The Glitch and the Fix, December 2014

Shake, rattle and roll

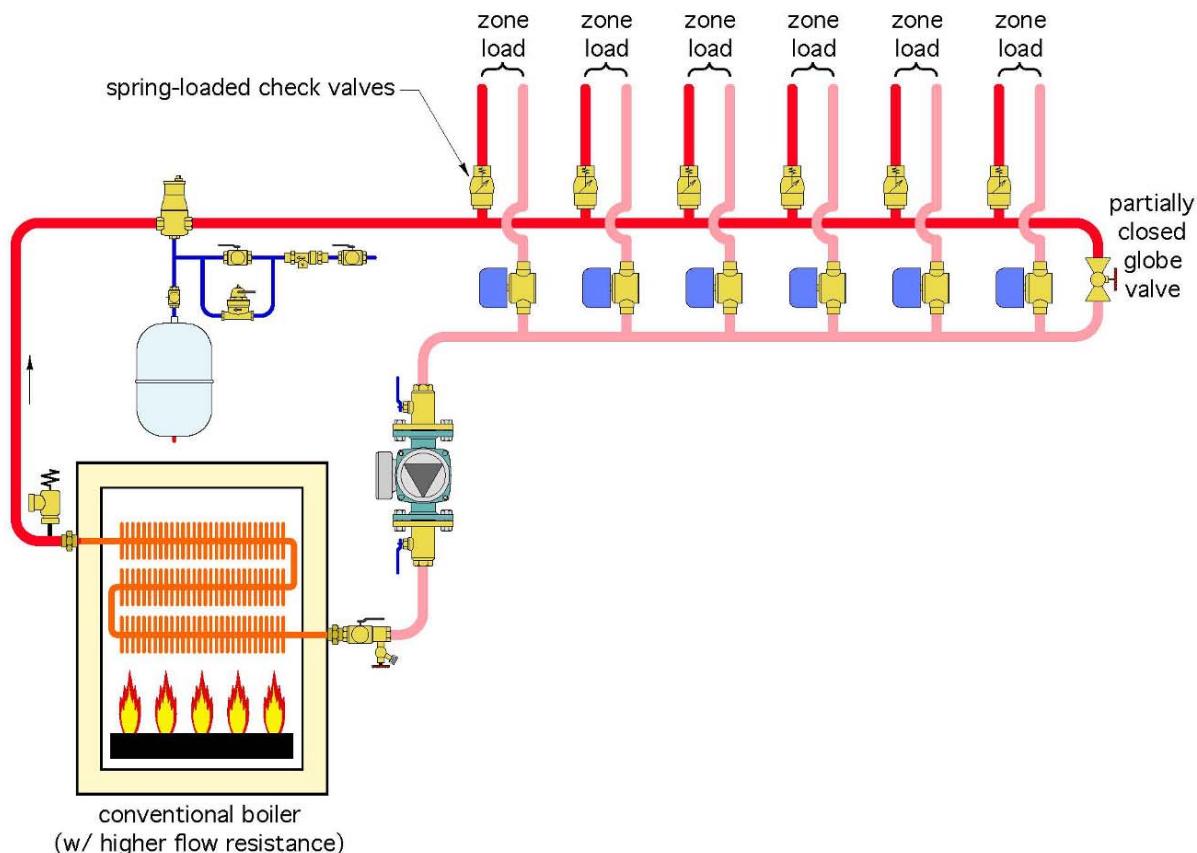
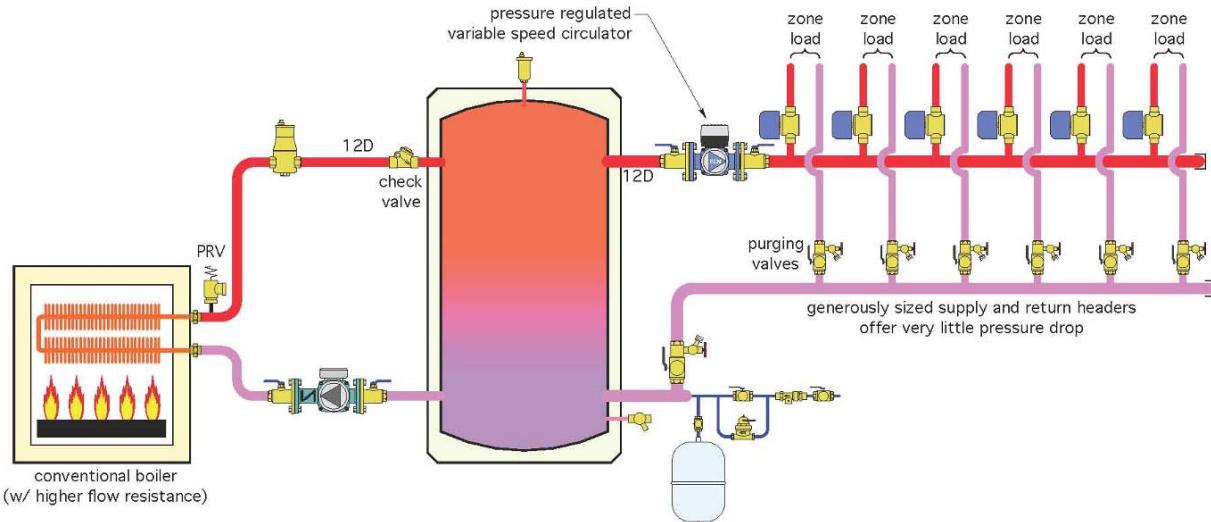
An installer sets up a zoned distribution system as shown below. To keep it simple, he uses the same size piping for the headers and all the distribution circuits. The heat source is a low-mass copper tube boiler with high flow resistance.

The distribution system operates at water temperatures high enough that sustained flue gas condensation will not occur. To prevent heat migration, he installs a spring-loaded check valve at the beginning of each zone circuit, just above the header. To control differential pressure, he installs a partially open globe valve across the ends of the headers. He sets the globe valve for one turn open.

1. The high flow-resistance boiler will create significant variation in zone flow rates depending on which zones are open. The boiler's low thermal mass can create noises from the boiler's heat exchanger under low flow conditions when only one or two zones are operating.

2. The partially closed ball valve is a poor excuse for proper differential pressure control across the headers. A variable-speed, pressure-regulated circulator is now the state-of-the-art method for providing such control in systems using valve-based zoning.

3. Headers should always be generously sized to minimize pressure drop along the length of the header. This plays a big part in providing hydraulic separation between the load circuits.

5. It's never a good idea to install check valves near fittings that creates high turbulence. This is the case with the check valves shown in the Glitch drawing. There should always be at least 12 diameters of straight piping upstream of any check valve to calm turbulence that otherwise will cause the check valve to rattle. However, heat migration in the Fix drawing is eliminated by simply installing the zone valves on the supply side of the zone circuits. Do this and there's no need for check valves on each zone circuit.

6. Purging valves on each zone circuit are missing in the Glitch drawing. They are shown in the Fix.
7. The circulator location in the Glitch drawing, in combination with the likely pressure losses of the piping system, puts the circulator in a “pumping toward” rather than a “pumping away” situation with respect to the expansion tank. Installing the expansion tank near the lower inlet of the buffer tank keeps the point of no pressure change close to the inlet of both circulators.

4. Any "flow sensitive" boiler supplying a system using zone valves should be decoupled from the distribution system through some means of hydraulic separation. In the Fix drawing, this is accomplished with a buffer tank, which also adds thermal mass to prevent boiler short-cycling.
